Planning Commission Regular Meeting

Tuesday, November 26, 2024

AGENDA ITEM: Request by Keystone Development Partners, LLC., for approval of a site plan to construct office/warehouses in the Biscayne Business Park.	AGENDA SECTION: PUBLIC HEARINGS
PREPARED BY: Anthony Nemcek , Senior Planner	AGENDA NO. 6.b.
ATTACHMENTS: Site Location, Existing Conditions, Site and Landscape Plan, Elevations and Floorplans, Renderings, Utility Plan, Engineering Review Memo dated November 18, 2024, Parks and Recreation Review Memo dated November 18, 2024	APPROVED BY: AK
RECOMMENDED ACTION: Motion to approve the site plan for Keystone Development Partners proposed office/warehouses in the Biscayne Business Park, subject to the following conditions being met prior to the issuance of a building permit: 1. Vacation of perimeter easements along existing interior parcel boundaries. 2. The applicant shall update the landscape plan to relocate two trees and provide an additional 65 foundation plantings. 3. The applicant shall combine the subject property into a single parcel. 4. The applicant shall provide verification of site lighting and, if necessary, a photometric study to prove conformance with site lig

No.:	Date: 10/22/2024
Drawn: bjj	Checked:
Project Manager:	
Project Status:	
Sheet Title: EXISTING/ REMOVAL PLAN	
Sheet No.: C2

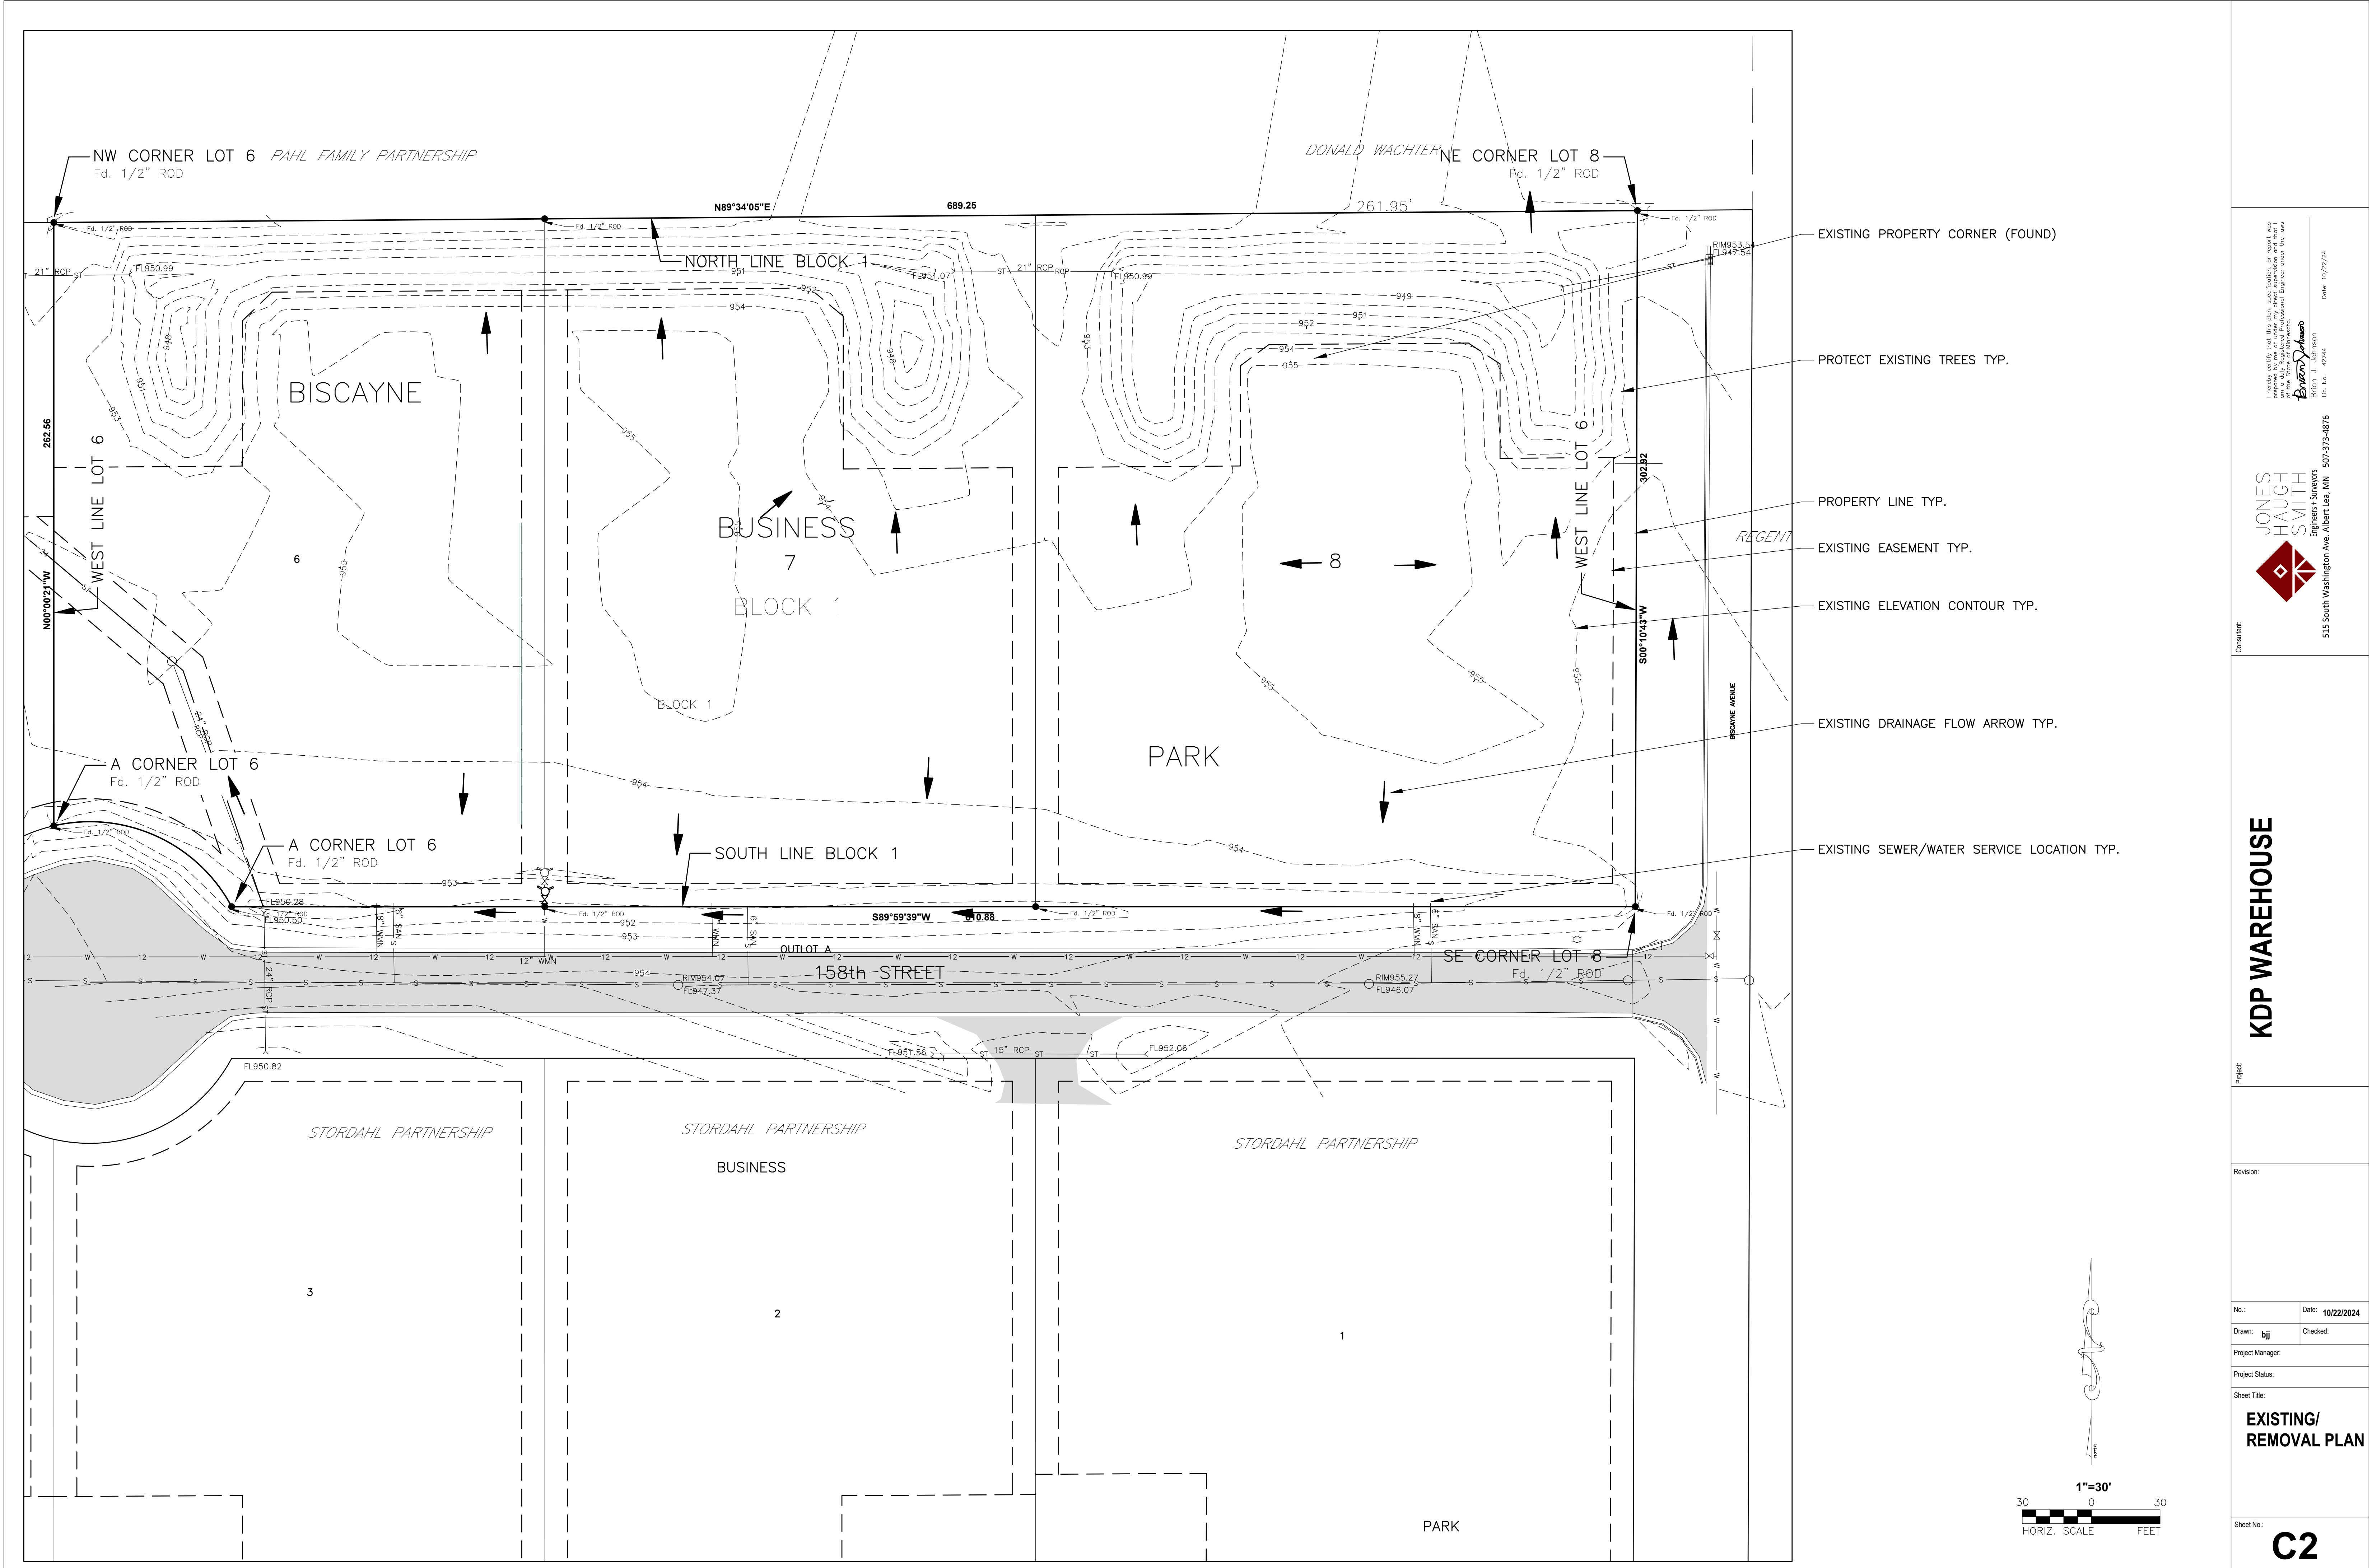
- The site is located north of 158th Street and west of Biscayne Avenue.
 - Provide copies all required permits to City.
- Existing Conditions/Removal Plan

- Verify with Public Works whether the existing service serving Lot 6 Block 1 would need to be removed or abandoned.
 - Show salvaging the existing hydrant assembly (w/ gate valve) and removing an additional length of hydrant lead pipe.

HARDSCAPE &
LANDSCAPE
PLAN

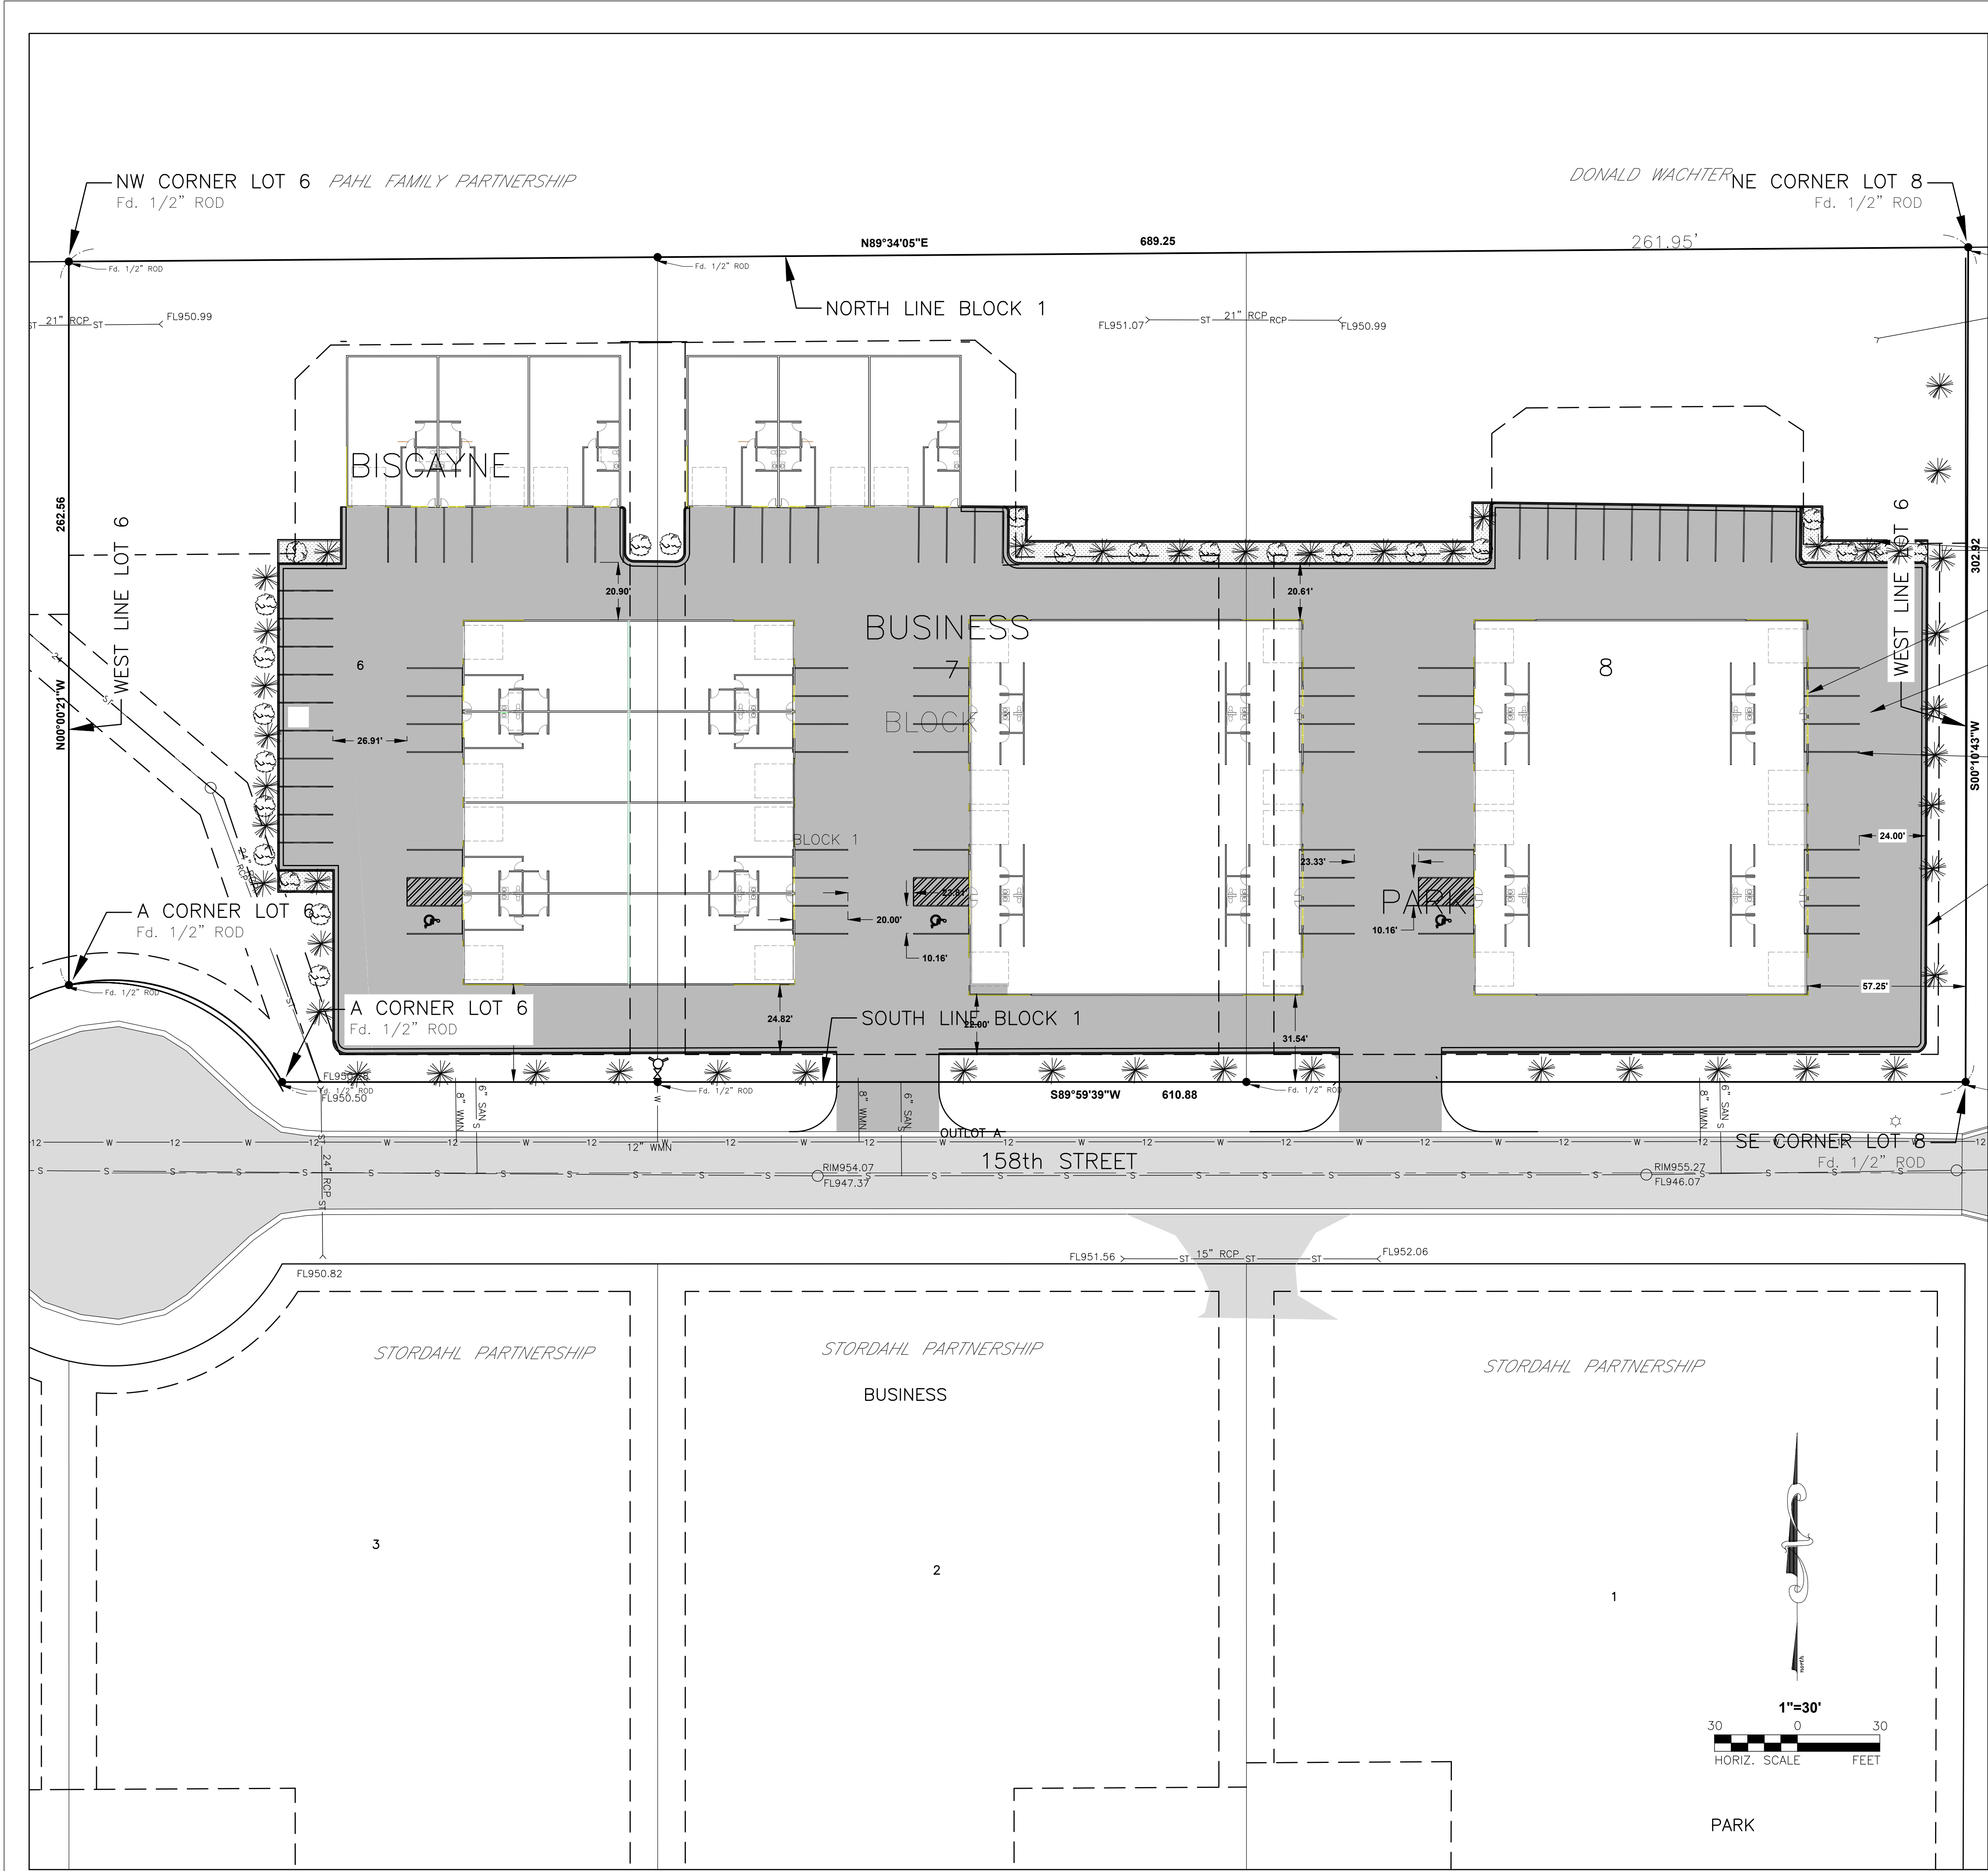
- Show installing salvaged hydrant assembly on Utility Plan
- Hardscape and Landscape Plan
 - Provide turning movements for all expected vehicles including emergency, garbage, and delivery vehicles (note impact of vehicles parked at loading bay doors on potential access)

- Provide garbage enclosure location and access
 - Fire Official to review emergency access
 - Parking in front of the large doors for each end unit will need to be restricted so that clear turning movements will be maintained

- Install commercial entrance per current City Standard Detail Plates

- i. Provide radii for turning at entrance
 - ii. Provide transitions (beaver tails) for any curb terminations
- c. Verify minimum drive lane requirements are being met between and around buildings
- d. Verify whether all drive lanes are bi-directional or whether some segments are one way
 - i. Provide signage and/or pavement markings as necessary
 - ii. Consider curb/barrier between building and driving lanes (typ.)
- e. Label typical parking spaces
 - i. Verify whether all spaces are 10'x20'
- f. Provide wheel stops or barrier between parking spaces and building (typ.)
- g. Parking spaces shown in front of entry doors (typ.)
- h. Verify need for minimum walking area in front of access doors (typ.)
